Access Compliance Report

Public Rights-of-Way

(Curb Ramps)

Intersection ID: 24499	Main Street: BECKMORE_PL	Cross Street: SAINTFIELD_PL	Location: SW
ADA ID: 065A1BD94F85	Ramp Type: Perp	Initial Pass/Fail: Fail	Overall Compliance: No
Severity Score: 1.25			
Codes/Mitigation Info/Possible Solution		Field Measurements/Component Compliance

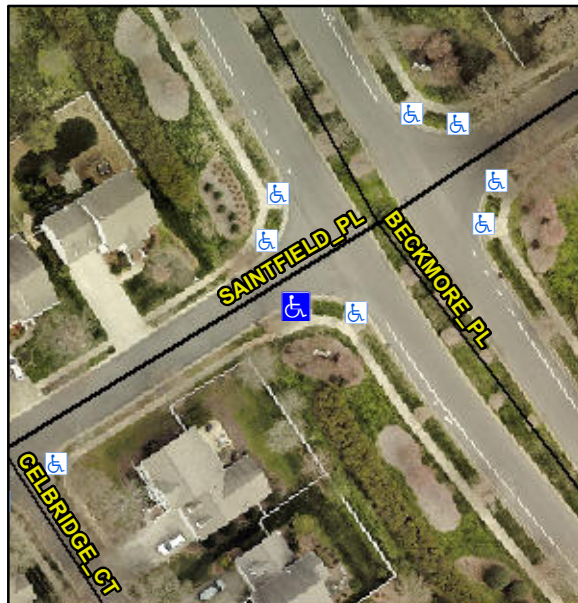
Not Found, R304.5.3

Compliance	Description	Data	Compliance	Description	Data
N/A	Ramp Length (in)	92.0	Yes	Ramp Slope (%)	7.3
Yes	Ramp Width (in)	48.0	No	Ramp XSlope (%)	2.4
N/A	Flare Type LT	N/A	N/A	Flare Type RT	N/A
N/A	Flare Slope LT (%)	N/A	N/A	Flare Slope RT (%)	N/A
N/A	Flare Traversable LT?	N/A	N/A	Flare Traversable RT?	N/A
N/A	Landing Length (in)	N/A	N/A	DWS Provided?	N/A
N/A	Landing Width (in)	N/A	N/A	DWS Contrast?	N/A
N/A	Landing Slope (%)	N/A	N/A	DWS Length (in)	N/A
N/A	Landing X Slope (%)	N/A	N/A	DWS Full Width?	N/A
N/A	Landing Curb? (Y/N)	N/A	N/A	DWS Offset (in)	N/A
N/A	Shared Landing?	N/A			
N/A	Gutter Ponding?	N/A	N/A	Gutter Slope (%)	N/A
N/A	Gutter Lip Ht (in)	N/A	N/A	Gutter X Slope (%)	N/A
N/A	Painted X Walk1?	No	N/A	Painted X Walk2?	N/A
	X Walk 1 Direction	To N		X Walk 2 Direction	N/A
N/A	X Walk 1 Width (in)	N/A	N/A	X Walk 2 Width (in)	N/A
	X Walk 1 Slope (%)	1.8		X Walk 2 Slope (%)	N/A
	X Walk 1 X Slope (%)	2.8		X Walk 2 X Slope (%)	N/A

Remove & Replace Entire Ramp.
